CITY OF ALBUQUERQUE

PLANNING DEPARTMENT – Development Review Services

Re: Vista Vieja Unit 3
Certification for Financial Guarantee Release
Cert Date 5-3-2011 – D09D003

March 2014

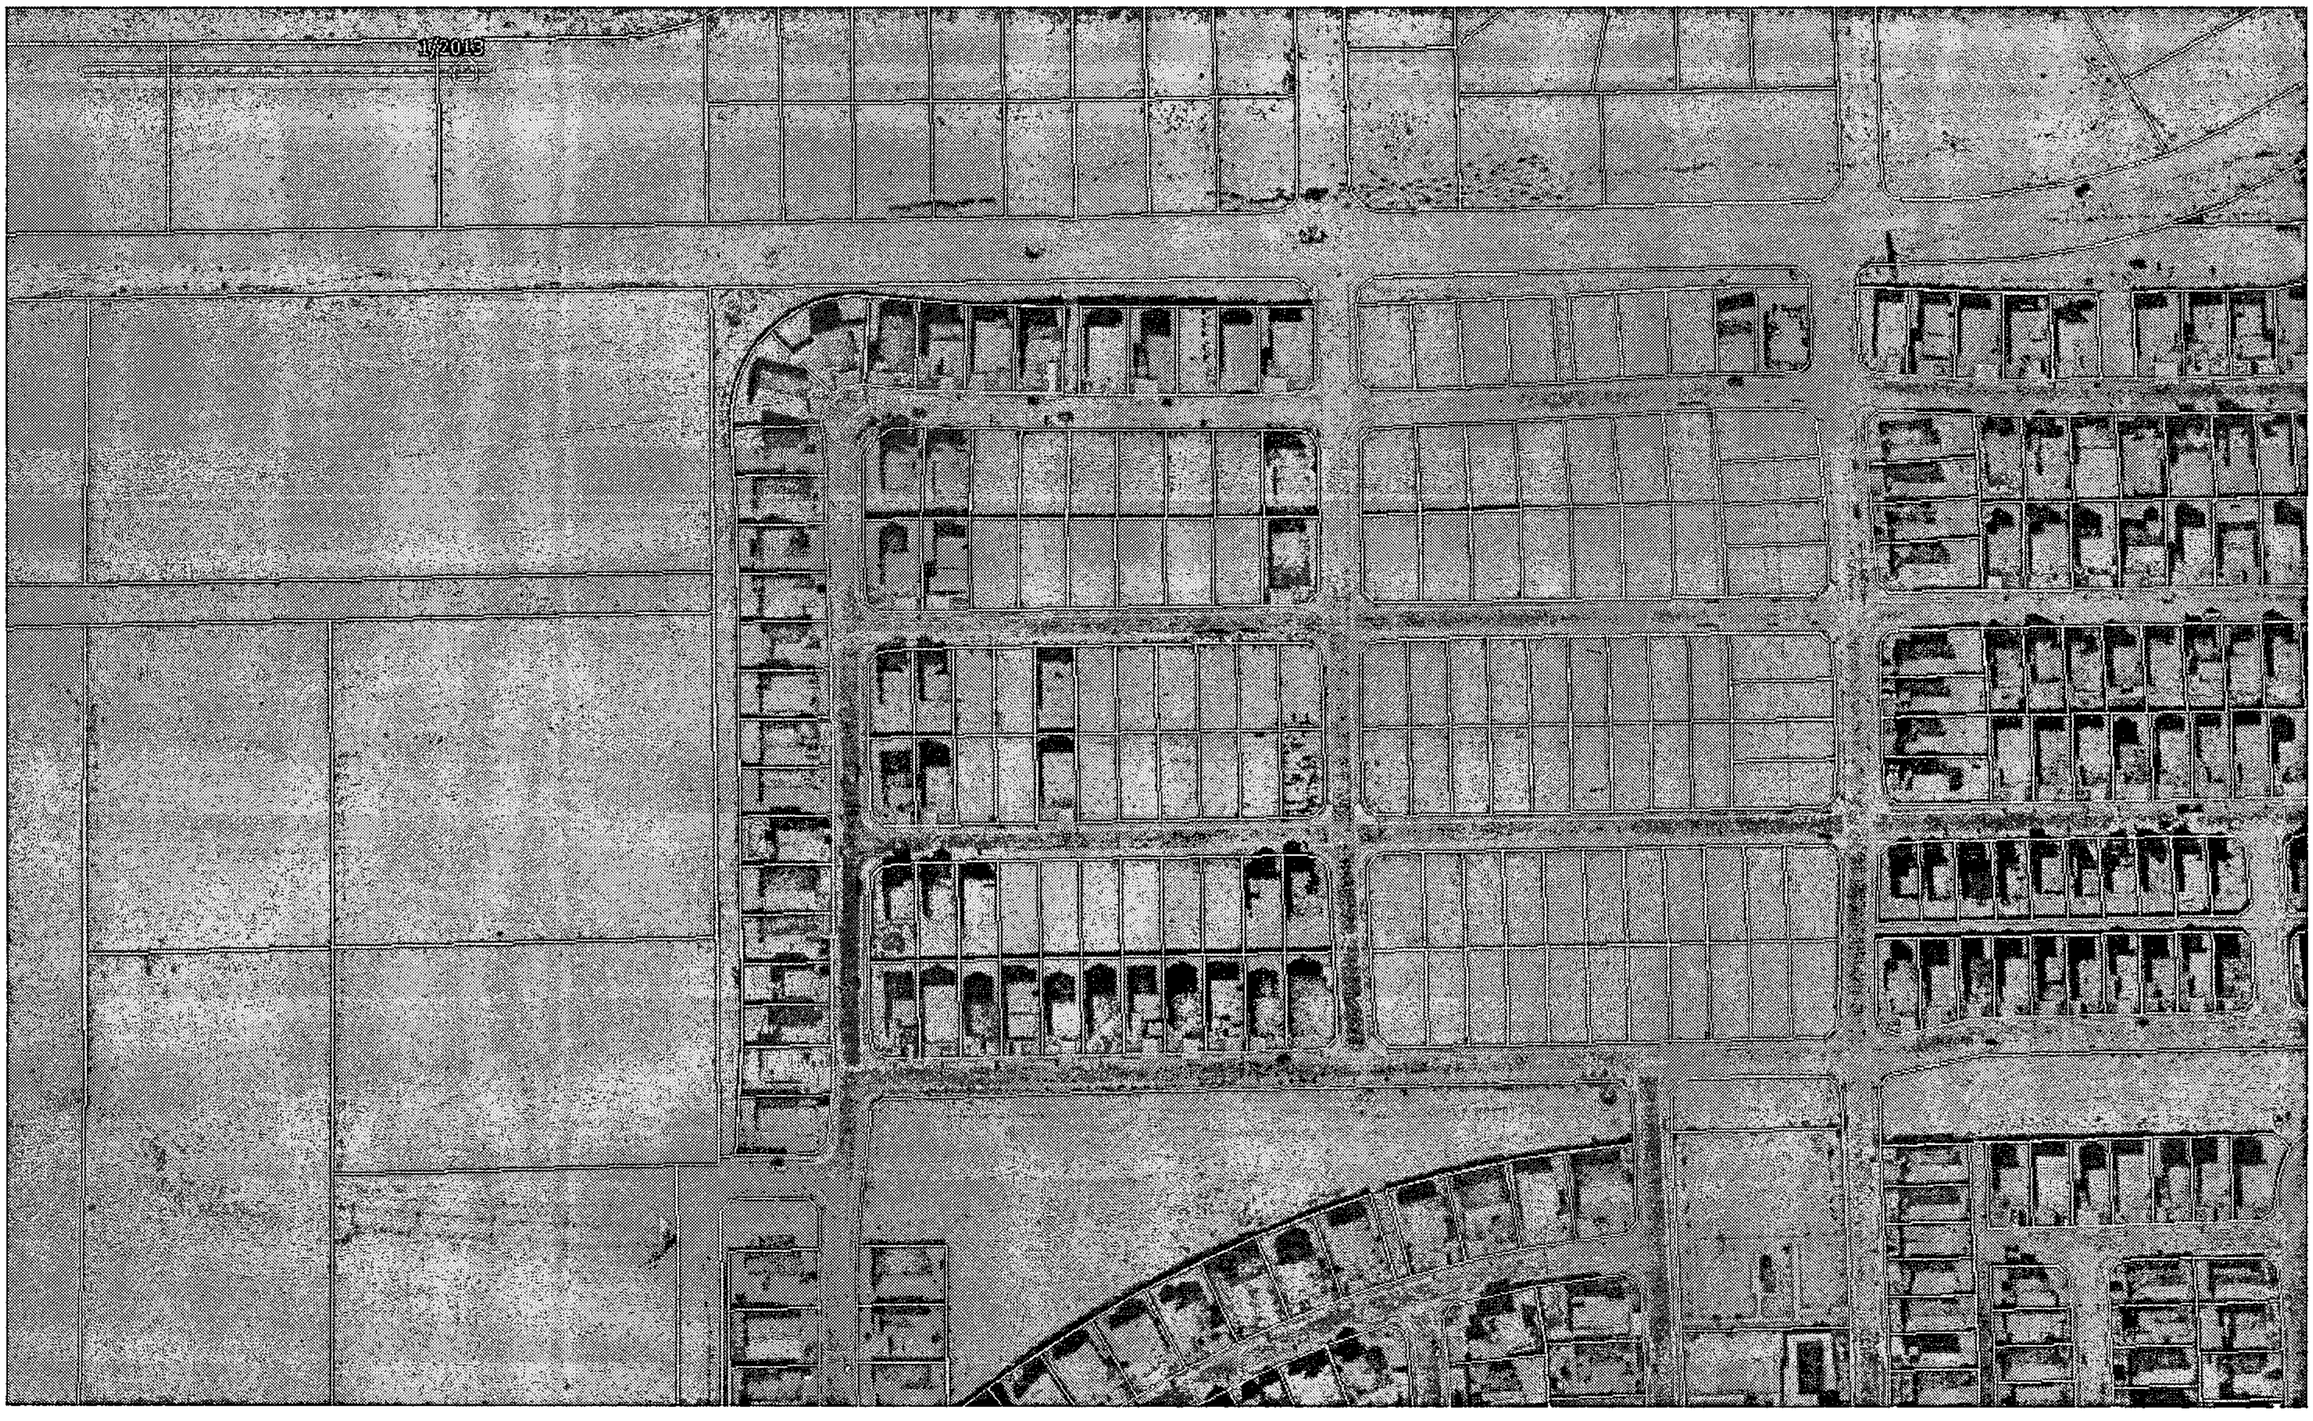
As of the date of this memo, a dirt pile and rubble exists within Scenic Drive right of way. However, after reviewing aerial photography between 2011 and 2014, there is enough evidence to show that the dirt pile was removed by the Vista Vieja development on or before August, 2011. A new dirt pile and stockpiling activity is visible in March 2014. Some activity adjacent to the right of way can be seen in January 2013 aerials. (Source: Google Earth Pro)

Figure 2: Looking south between downstream toe of embankment and west edge of subdivision.

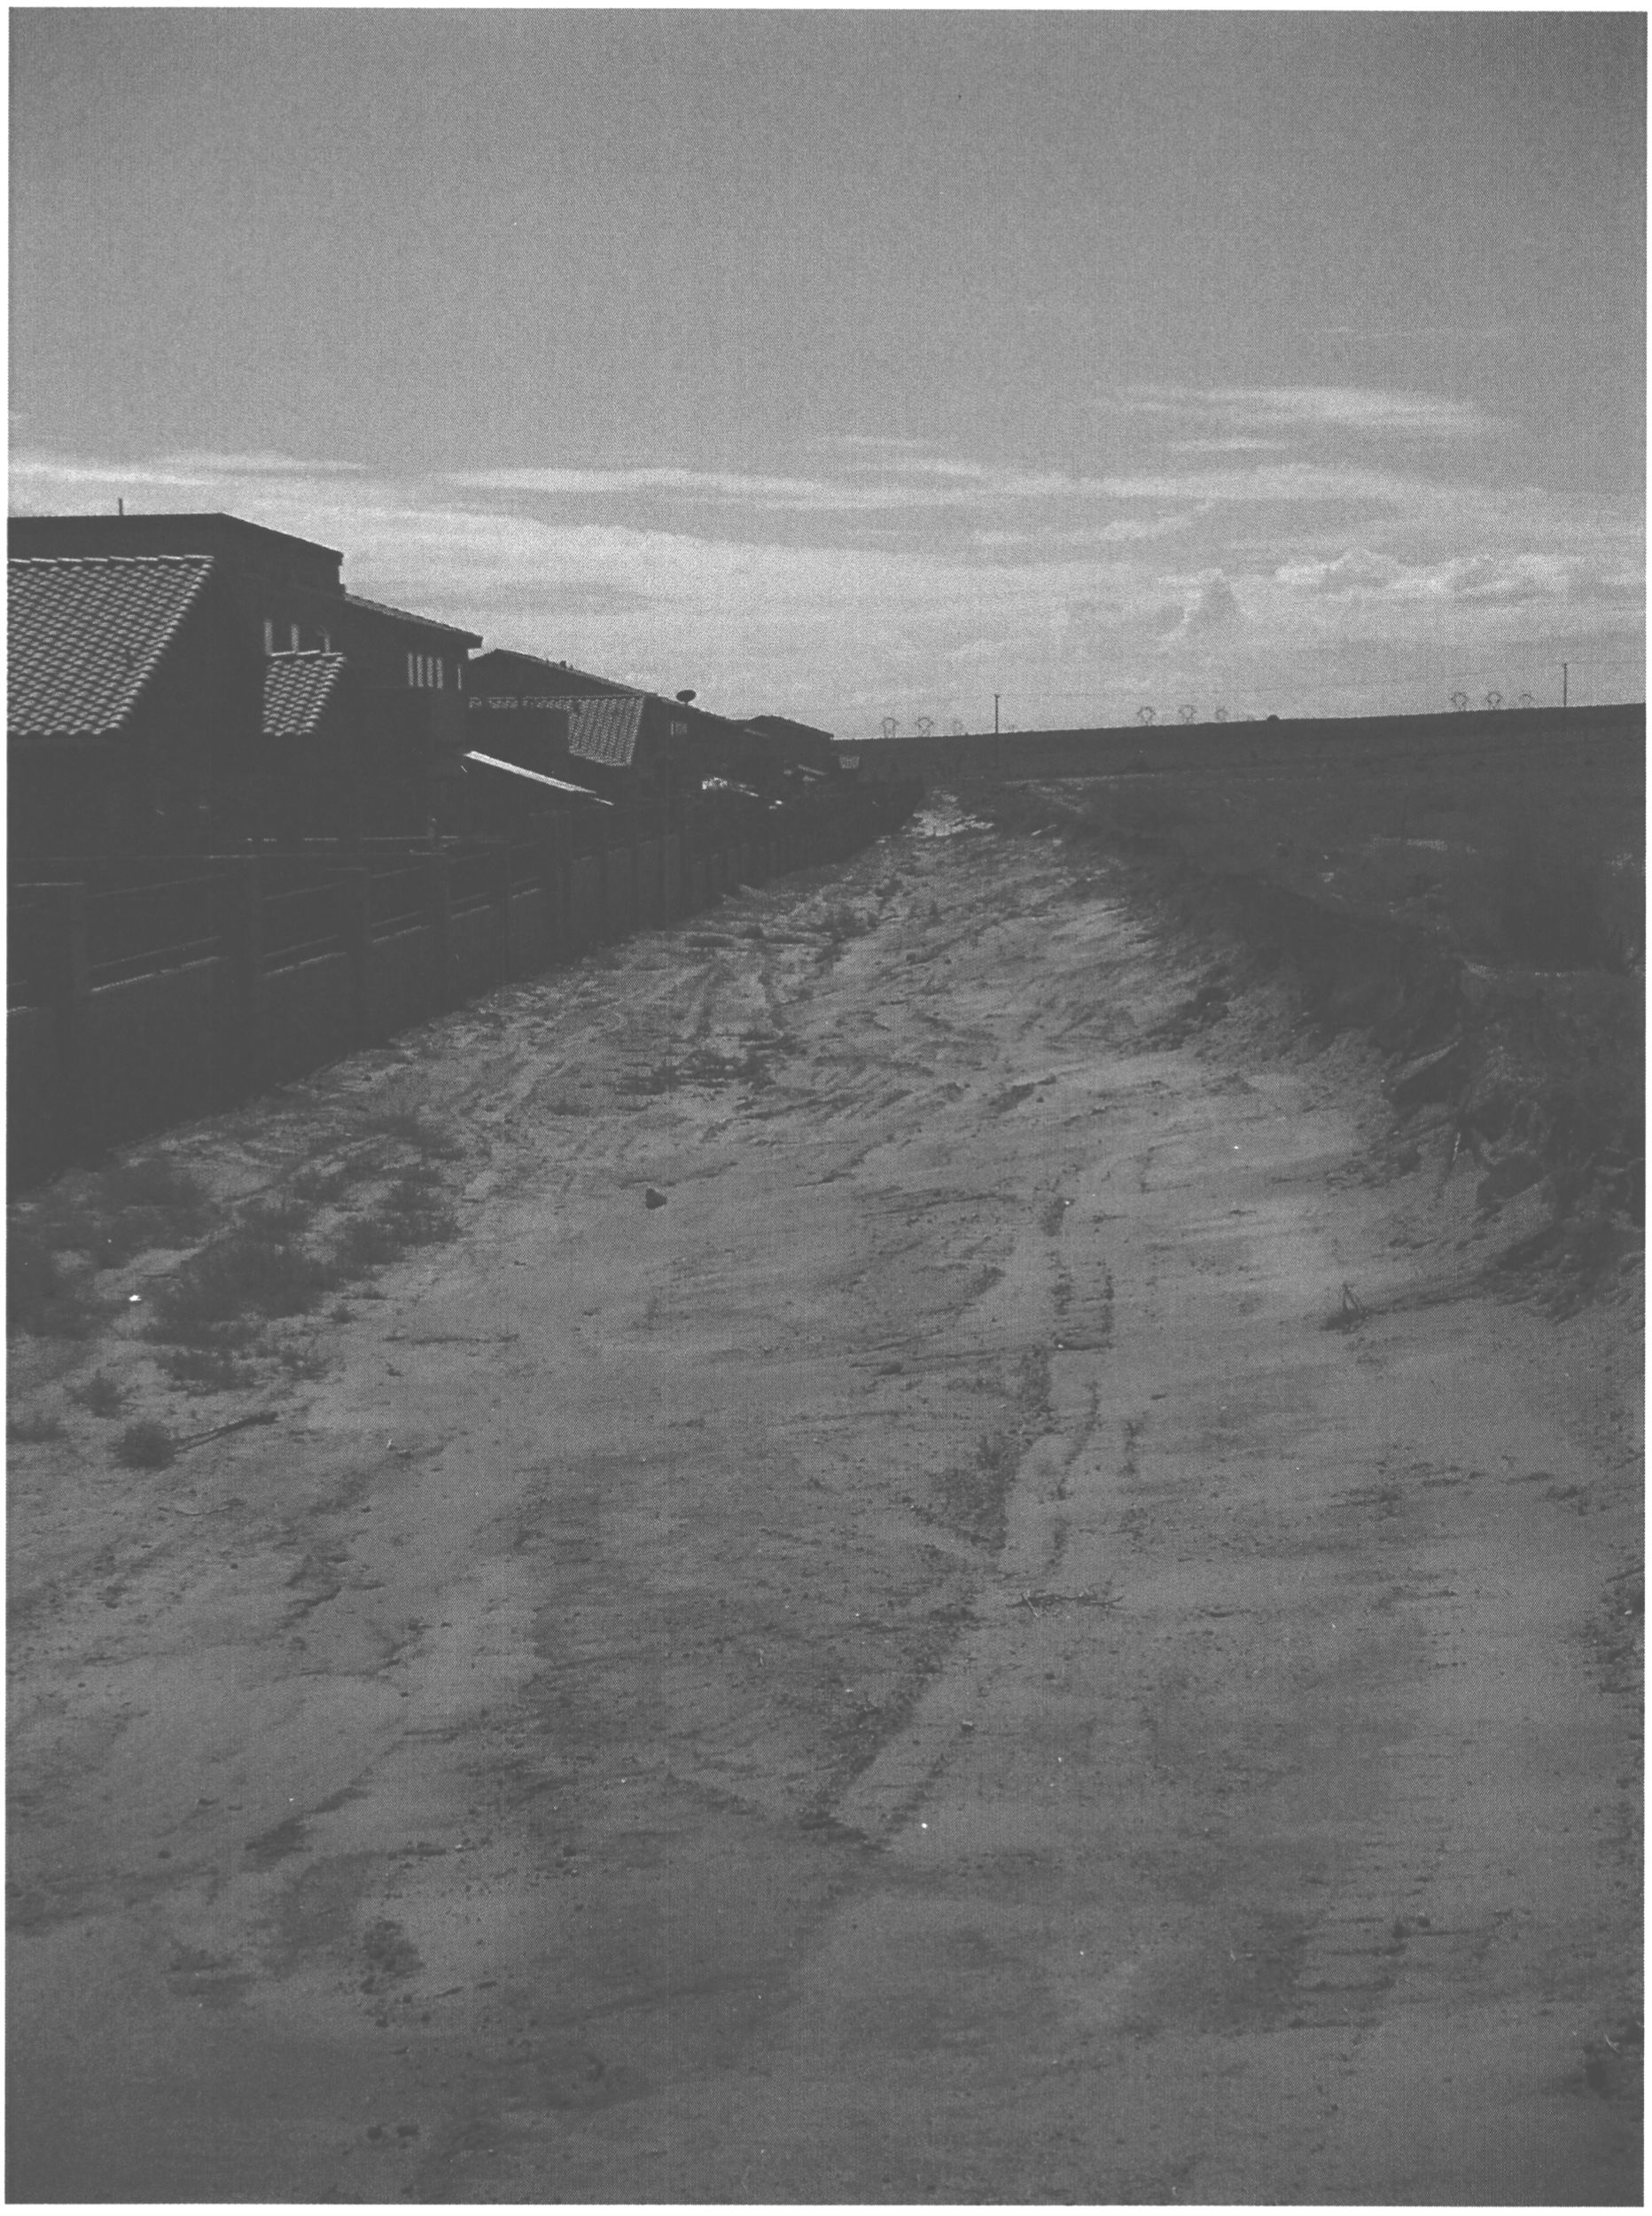
The area directly downstream of the embankment did show ponding. There is an area about 12 wide that has been cleared between the embankment and the homes back walls. This area is not graded to drain and has accumulated water. It is likely that this water, see Figure 2, is from this area and the downstream slope of the dam.

Looking upstream in the channel, see Figure 4, there does not appear to be any degradation of the improvements nor substantial sediment.

The installed infrastructure appears to be working as planned. The grading between the embankment and the subdivision is likely trapping water and may need to be looked at. In addition the area to the northwest of the subdivision may need to be analyzed to determine where is was intended to drain to.

Figure 1: Embankment outlet structure

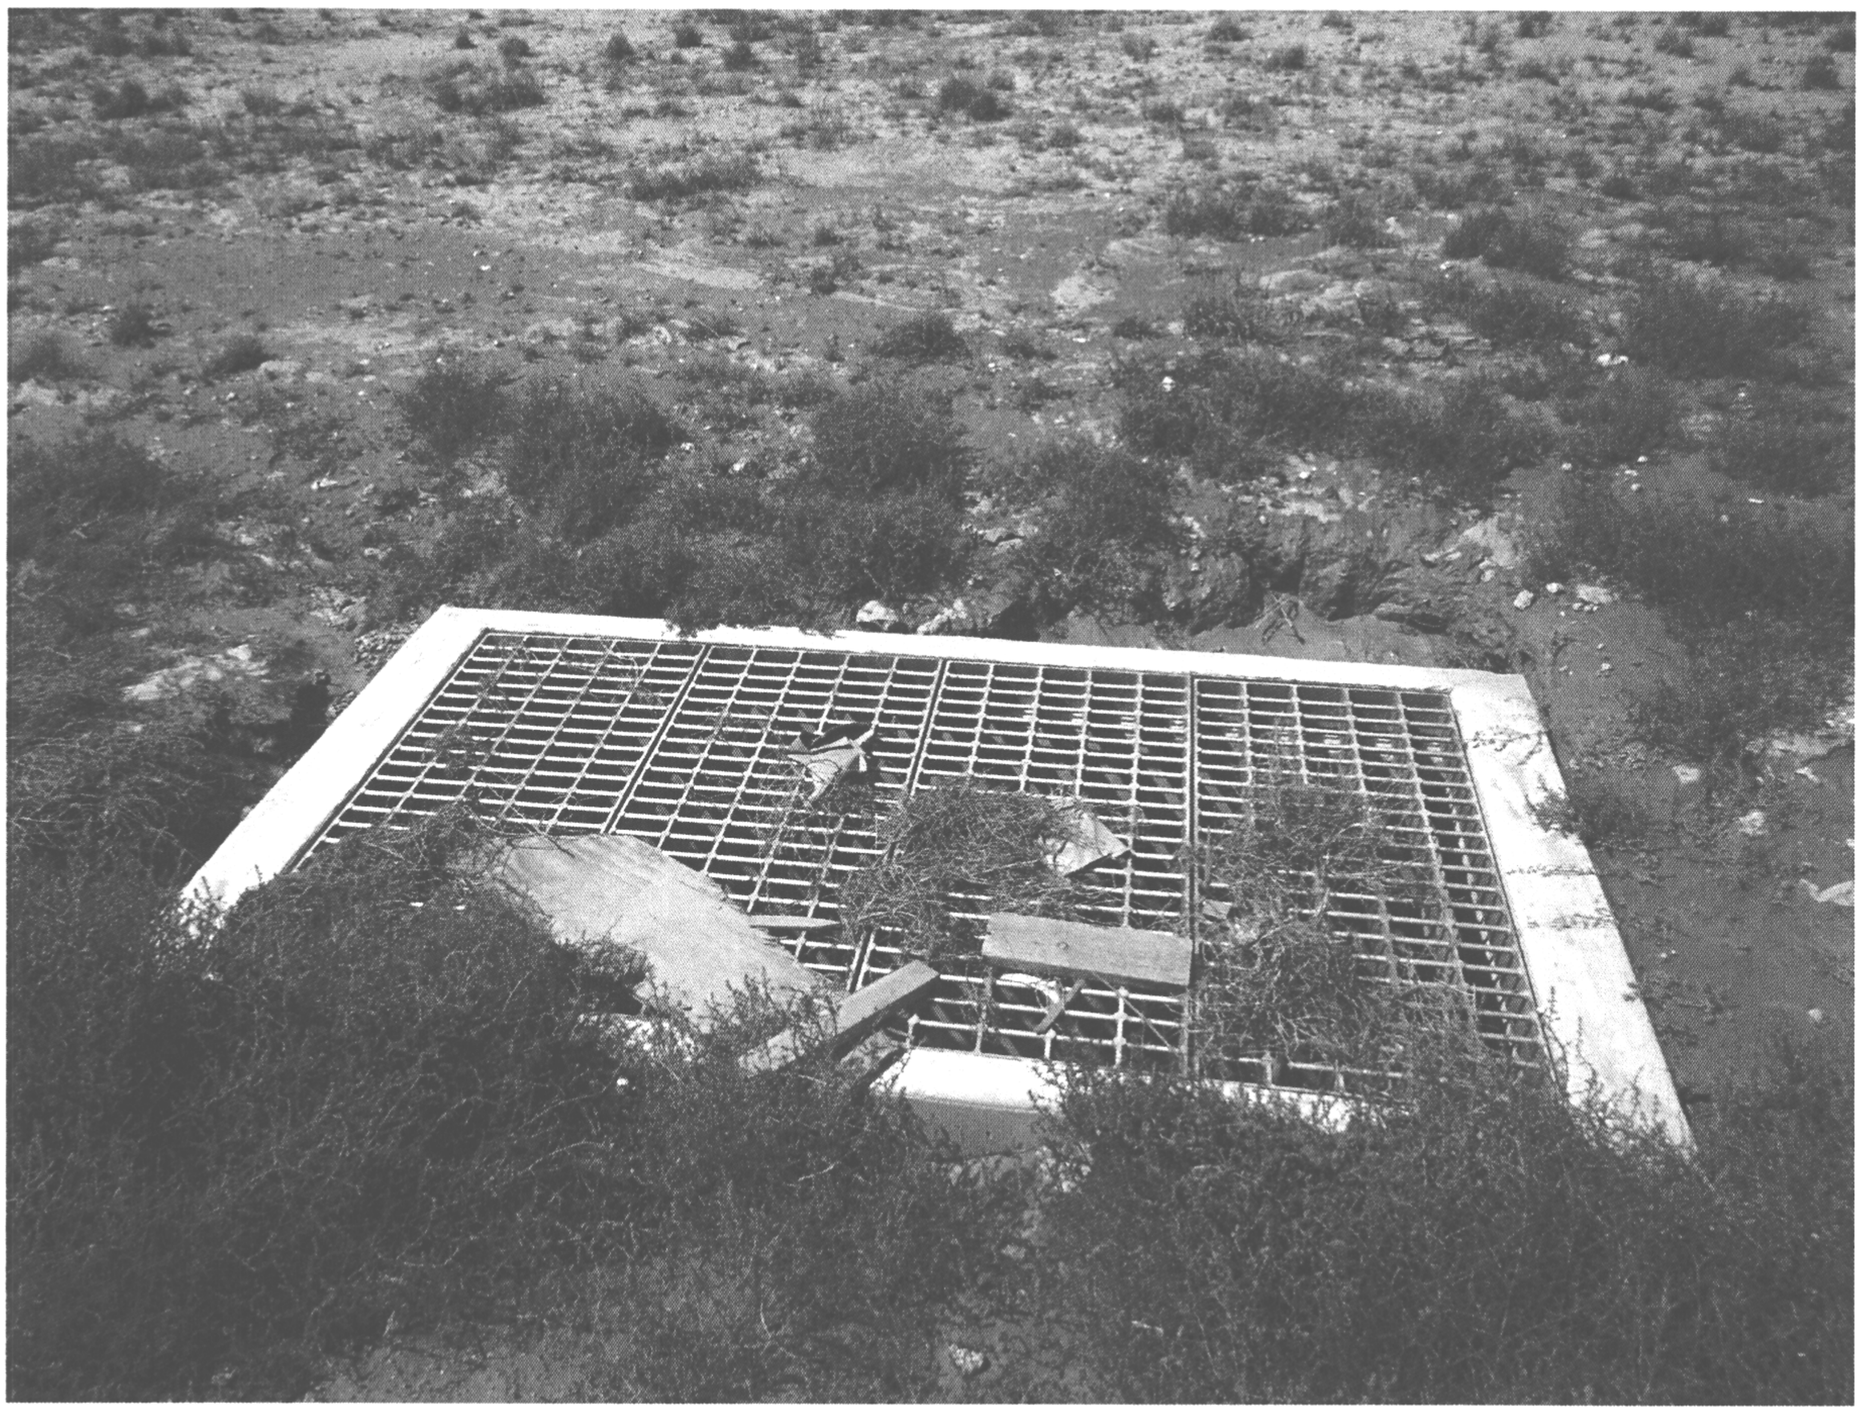
The embankment appears similar to after construction. The outlet structure, see Figure 1 was mostly clear and appeared to be functioning correctly. There was some minor subsidence on the western side of the outlet, but did not appear concerning. The embankment did not show any signs of over-topping
